Hi Folks,

Below are images with the changes we discussed today. There is also an option at the end of the document for a slightly different layout of the office and sorting area for consideration and feedback.

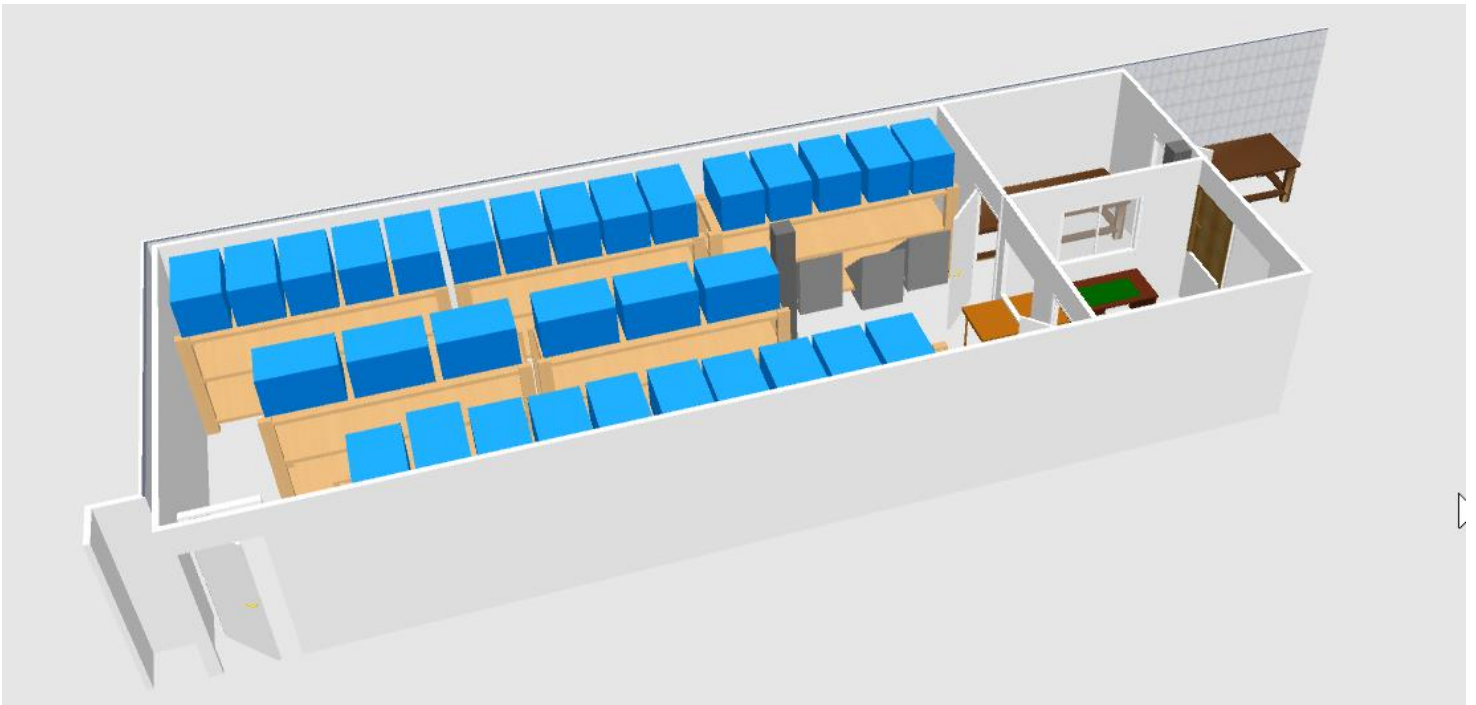
The 3 primary changes to the optional layout below are and each option can be implemented independently:

1. The pass through for the bin comes directly from/to the office,
2. The end wall has been moved 30 cm out further to accommodate a 345cm (11' 6") table
3. A door and window have been added to the office for outside viewing and access.
